Timnath-Connell Pit SWSP Approval

Re: Timnath-Connell Substitute Water Supply Plan (WDID 0302526, Plan ID 3615)
Timnath-Connell Pit, DRMS File No. M-1999-050 (WDID 0303018)
Section 3, T6N, R68W, 6th P.M.
Water Division 1, Water District 3, Larimer County

Approval Period: April 1, 2018 through March 31, 2019
Contact Information for Mr. Williams: 303-653-3940; tlwwater@msn.com

Map 2

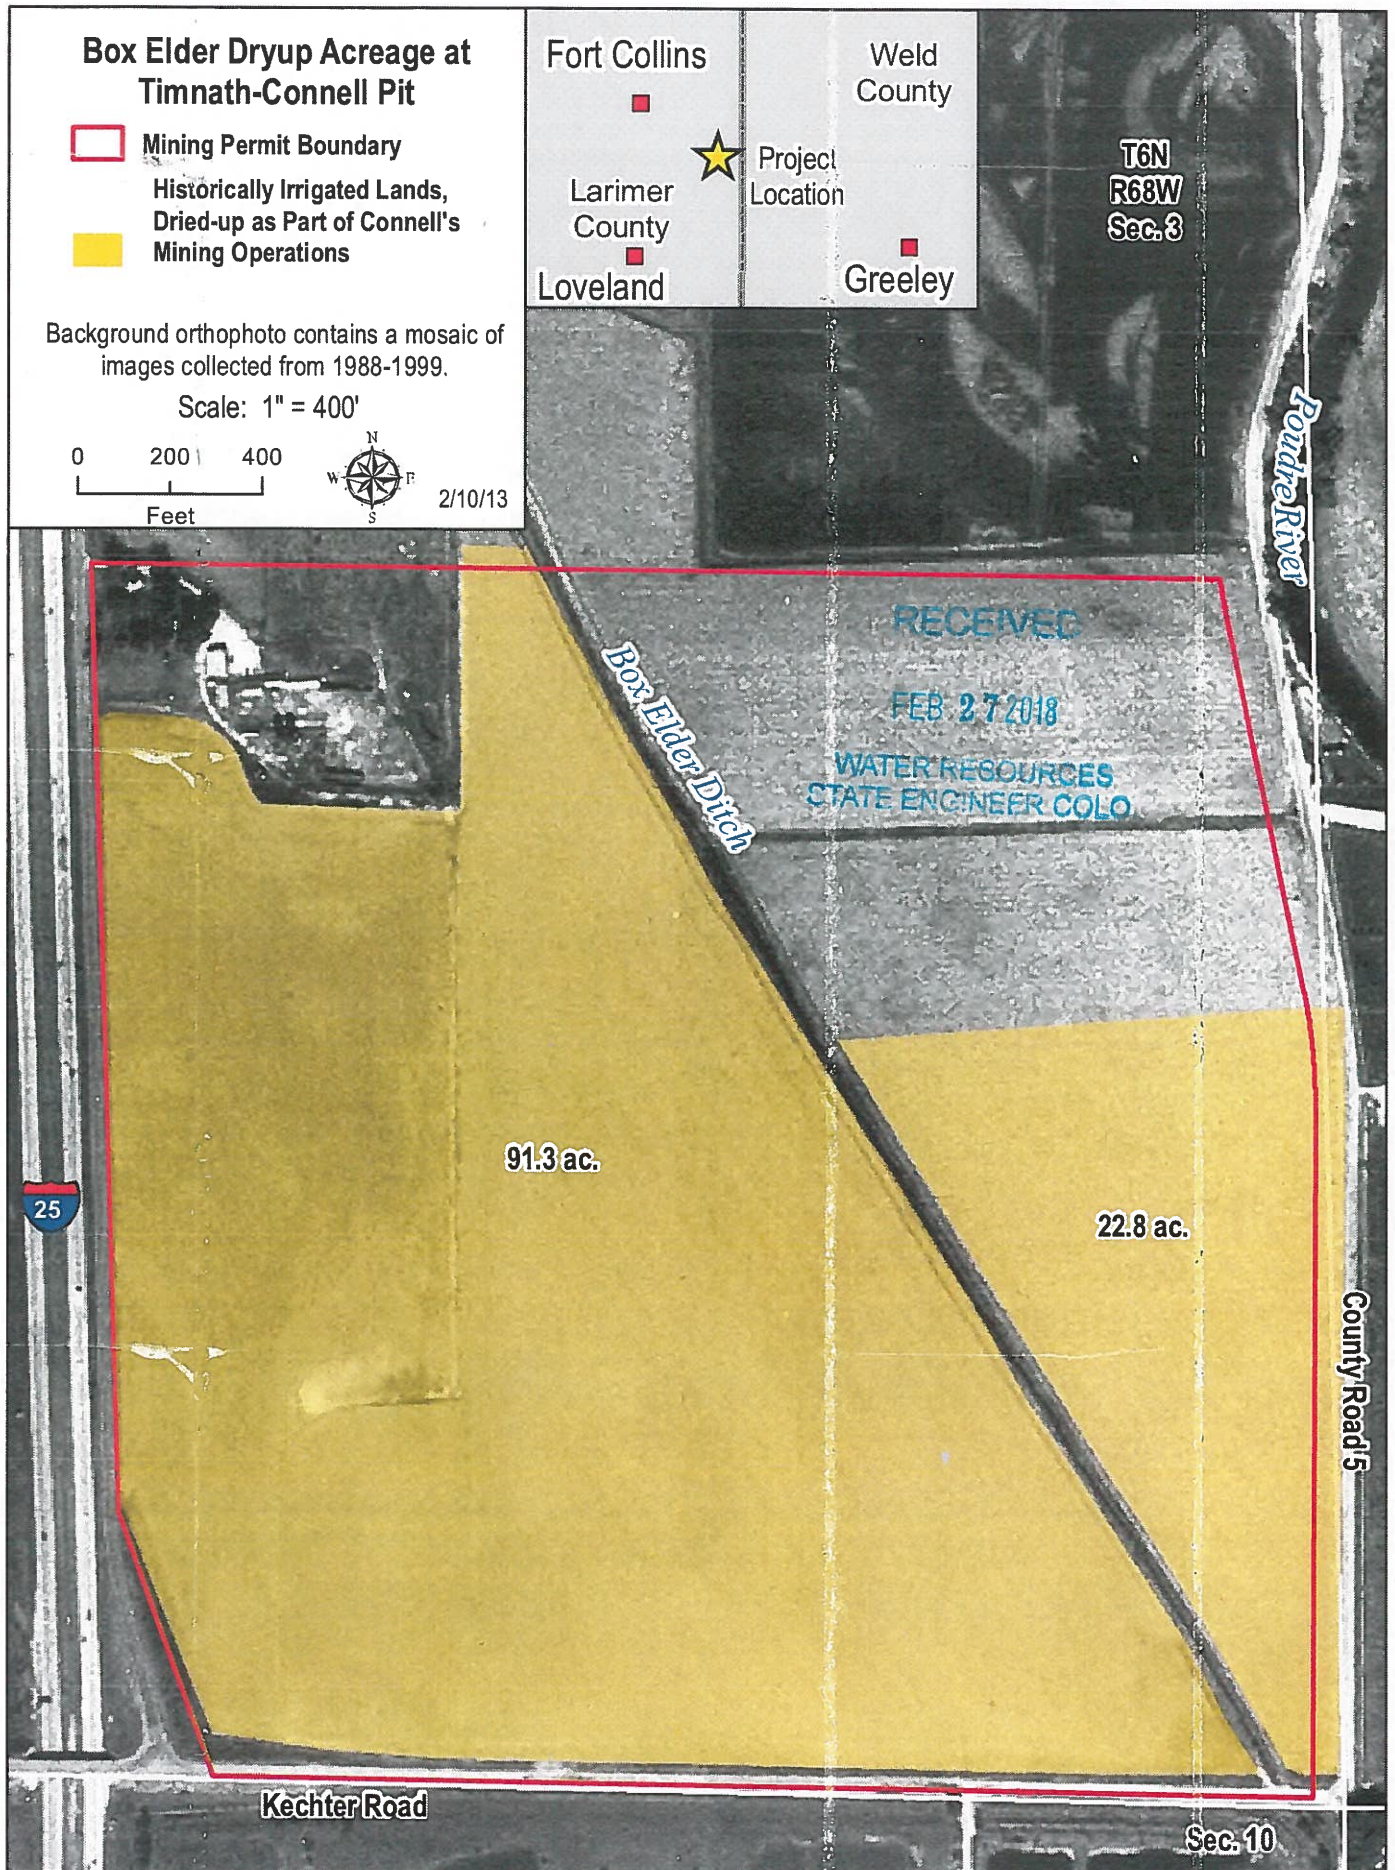
16. Conveyance loss for delivery of augmentation water to is subject to assessment and modification as determined by the division engineer.
17. The amount and location of the dry-up of the irrigated acreage associated with the subject 2.5 shares of the Box Elder Ditch Company has been previously documented and approved by the division engineer and water commissioner (see attached Map 2).
